1 / End-wall and screw-boss correction

2 / Retainer definition, positions and assembly

Basis: approved B26-INTEGRATED-01 + B26-DETAIL-01 sheet 3; only described boss/bridge delta changes.

PLAN DETAIL / positive u end / F01-F04, 8:1 (local u right, v down)

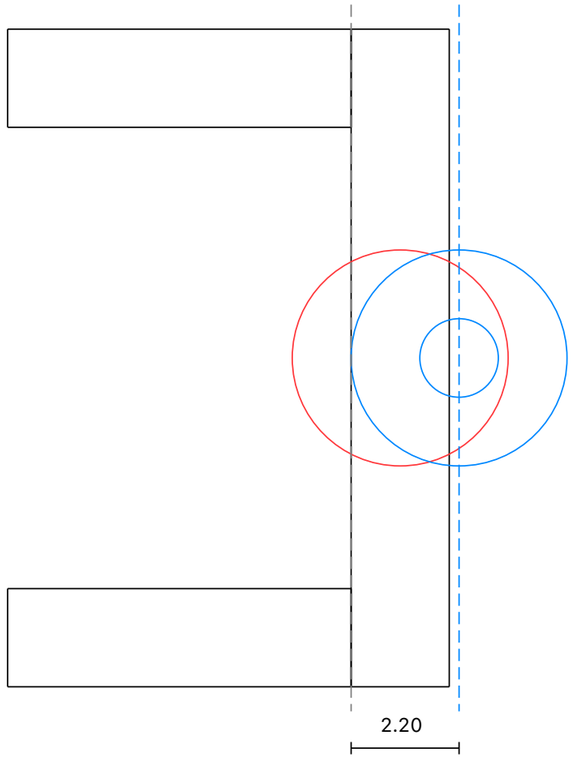
Existing end wall and wings remain in B26 positions. Same positive/negative-u correction at each end.

Wall inner face |u|=31.75 (F01-F04) / 31.60 (F05). Post radius 2.20, pilot radius 0.80.

New axis = wall inner face + 2.20; new post inner face is flush with the wall inner face.

Current post axis is wall inner face + 1.00; each post/pilot moves outward 1.20 from B26.

No change to fader center, walls, wings, bottom rails, blade, cap or panel slot.

HOLD: check all boss/support/retainer neighbors, screw heads and driver envelopes before any release.

Approval of this named drawing is required before modifying B26 CAD geometry.

RETAINER PLAN / positive u end / all five faders / 8:1

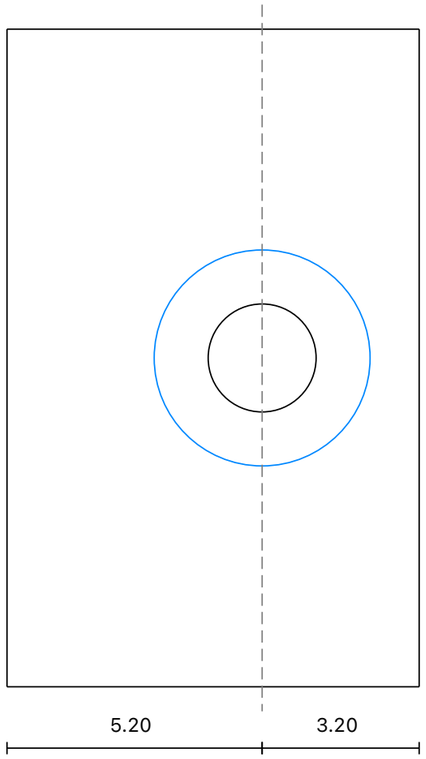
8.40 x 13.40 x 1.50; centered v=0. Through D2.20; 90-degree countersink D4.40 top.

Top D4.40 meets bottom D2.20 at 1.10 below retainer top. Nominal outside material at outer end = 1.00.

Inner edge remains |u|=28.75 / 28.60; outer edge |u|=37.15 / 37.00; axis |u|=33.95 / 33.80.

First value F01-F04, second F05. Reverse u sign for the opposite end; z positions remain as B26.

F01/F02/F03/F04: pilot axes +/-33.95, spacing 67.90; F05 +/-33.80, spacing 67.60.

Inherited trial fastener: M2x6 countersunk, max head D4.40; pilot D1.60, modeled depth 5.50.

Nominal 60 mm body gives 1.75 mm (F01-F04) / 1.60 mm (F05) per end to boss at centered pose.

Actual body/tabs, screw head, accessible driver, panel interaction, retention and PETG strength TBD.
